Attachment to AEP:NRC:0659B
Donald C. Cook Nuclear Plant Unit Nos. 1 and 2
Proposed Technical Specifications Changes

FIGURE 6.2-2 FACILITY ORGANIZATION - DONALD C. COOK - UNIT No. 1

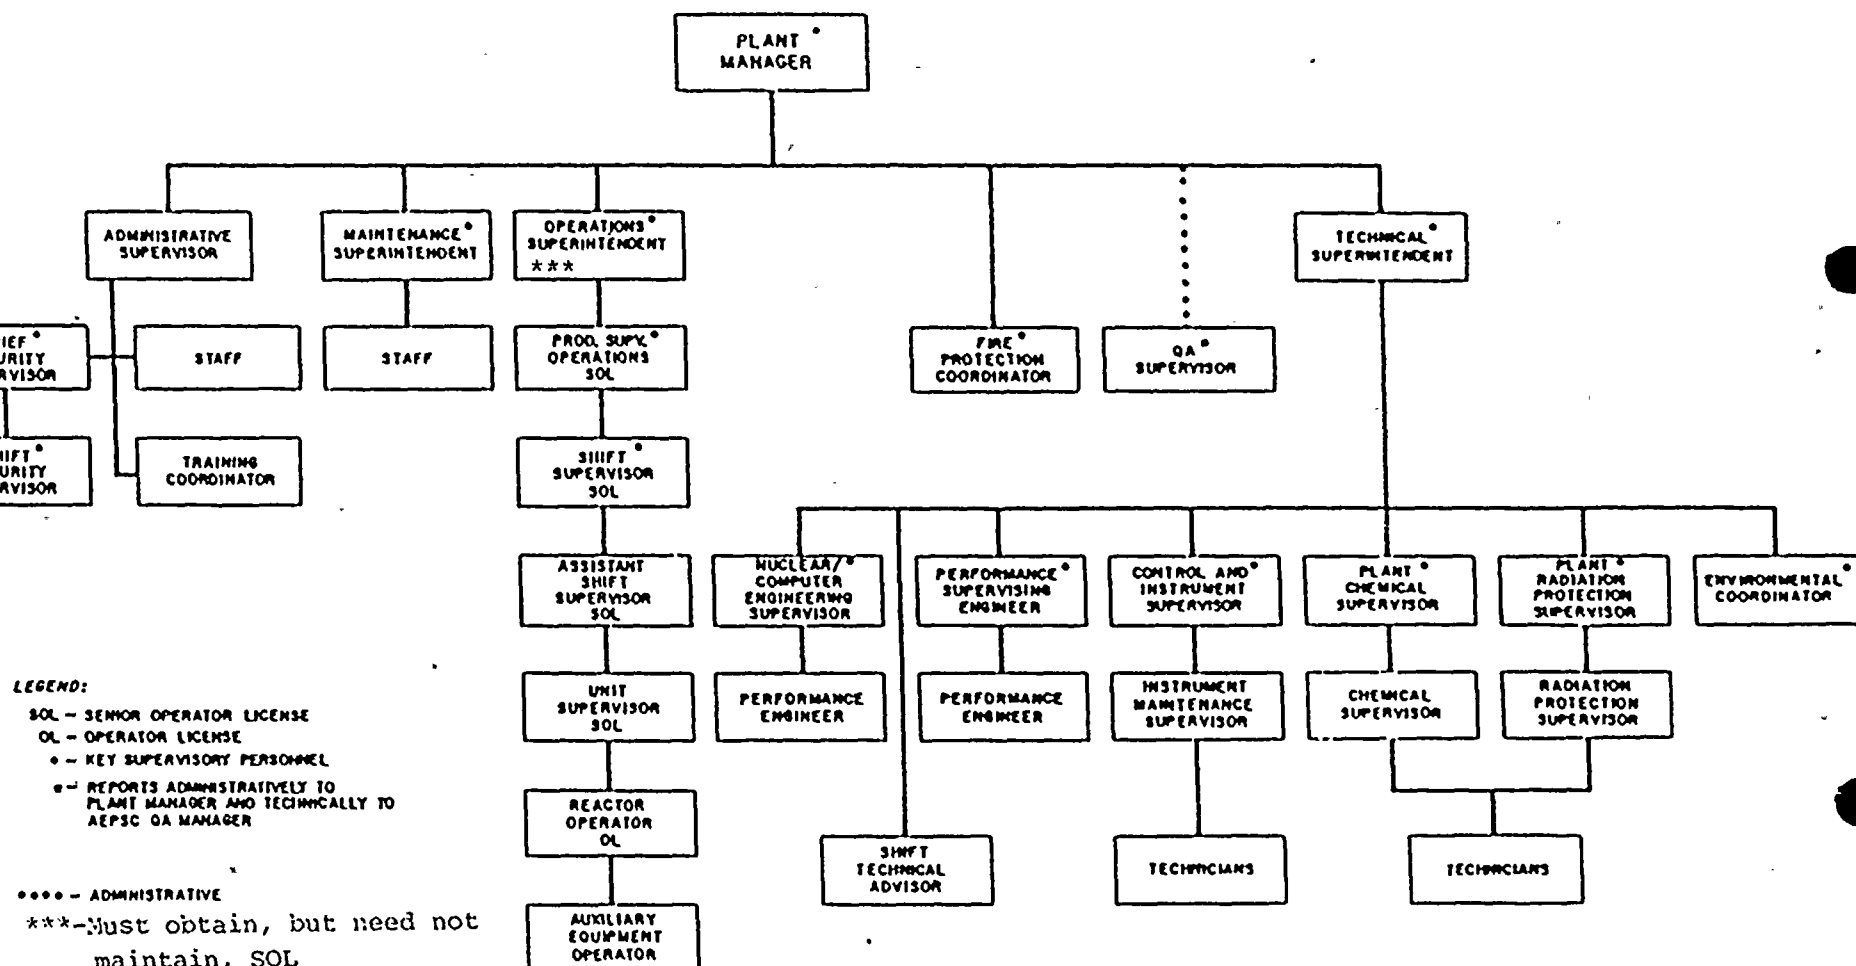
6.3.1 Each member of the facility staff shall meet or exceed the minimum qualifications of ANSI N18.1-1971 for comparable positions, except for (1) the Radiation Protection Supervisor who shall meet or exceed the qualifications of Regulatory Guide 1.8, September 1975, (2) the Shift Technical Advisor who shall have a bachelor's degree or equivalent in a scientific or engineering discipline with specific training in plant design, and response and analysis of the plant for transients and accidents, and (3) the Operations Superintendent who shall obtain his Facility Senior Reactor Operator's License within two years if he has never held a Facility Senior Reactor Operator's License. However, he shall not be required to maintain the license.

FIGURE 6.2-2 FACILITY ORGANIZATION - DONALD C. COOK - UNIT No.2

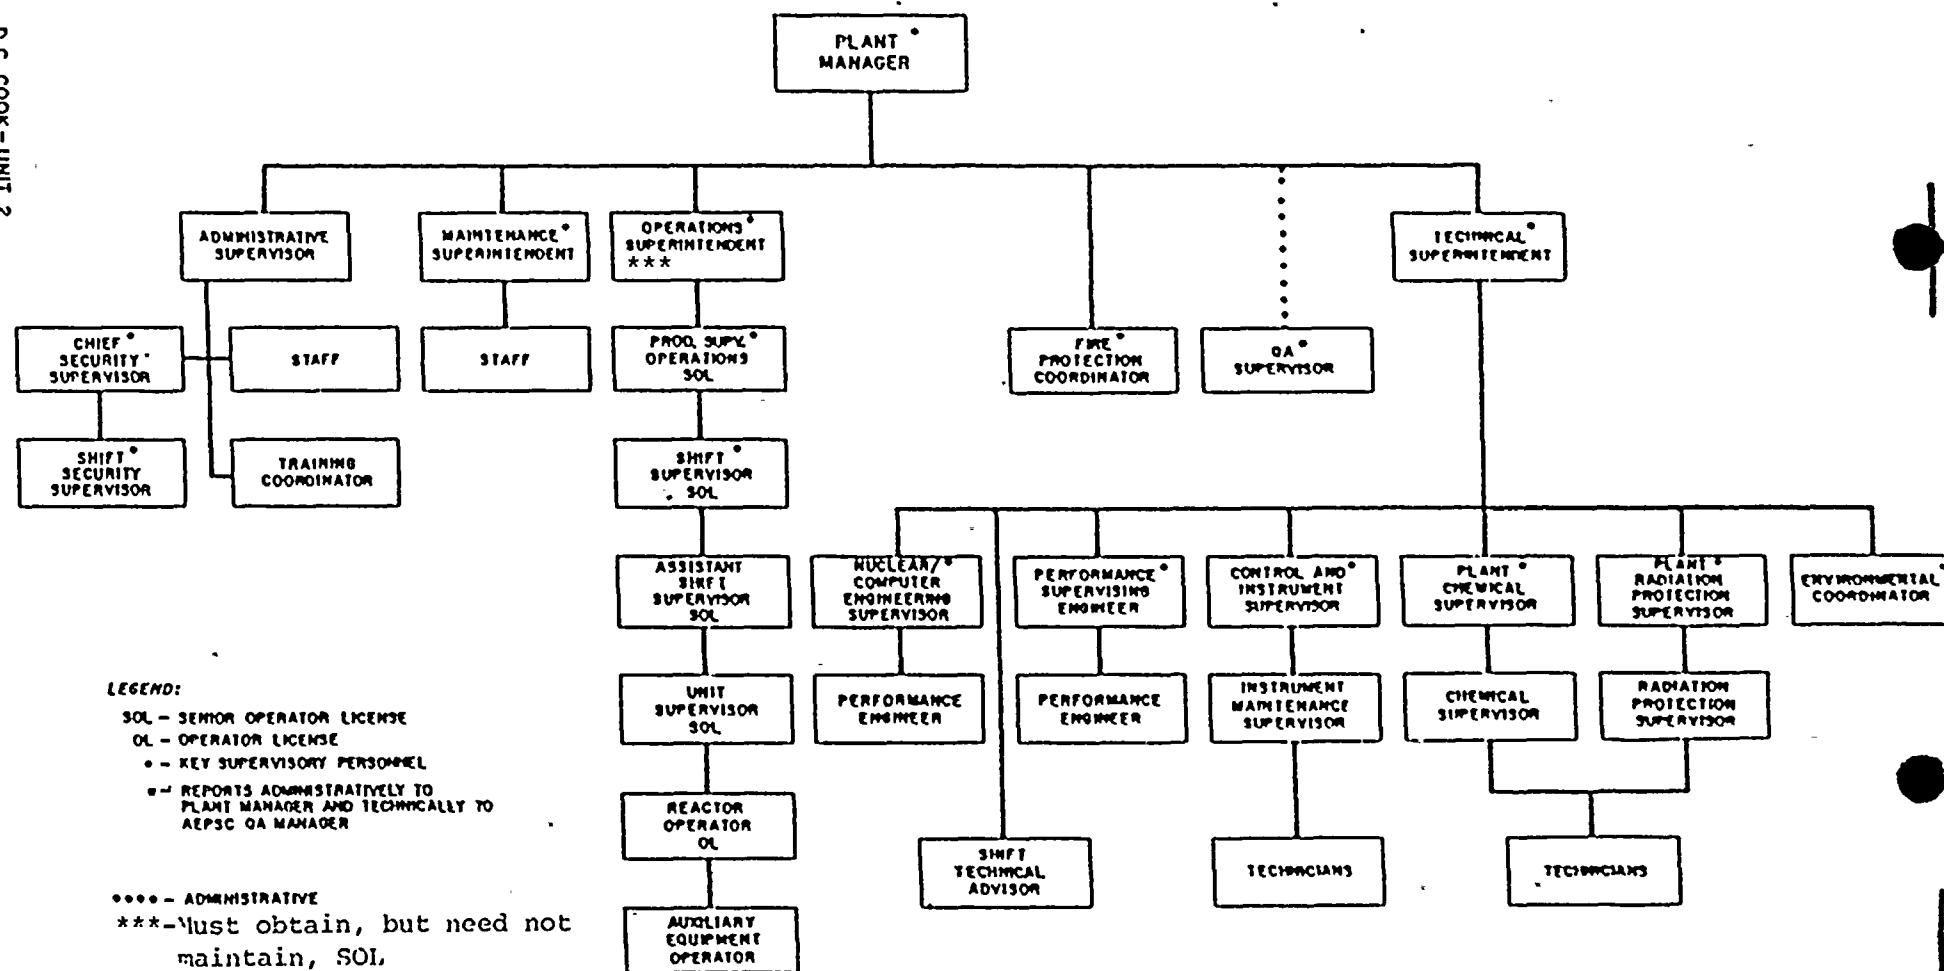
6.3.1 Each member of the facility staff shall meet or exceed the minimum qualifications of ANSI N18.1-1971 for comparable positions, except for (1) the Radiation Protection Supervisor who shall meet or exceed the qualifications of Regulatory Guide 1.8, September 1975, (2) the Shift Technical Advisor who shall have a bachelor's degree or equivalent in a scientific or engineering discipline with specific training in plant design, and response and analysis of the plant for transients and accidents, and (3) the Operations Superintendent who shall obtain his Facility Senior Reactor Operator's License within two years if he has never held a Facility Senior Reactor Operator's License. However, he shall not be required to maintain the license.
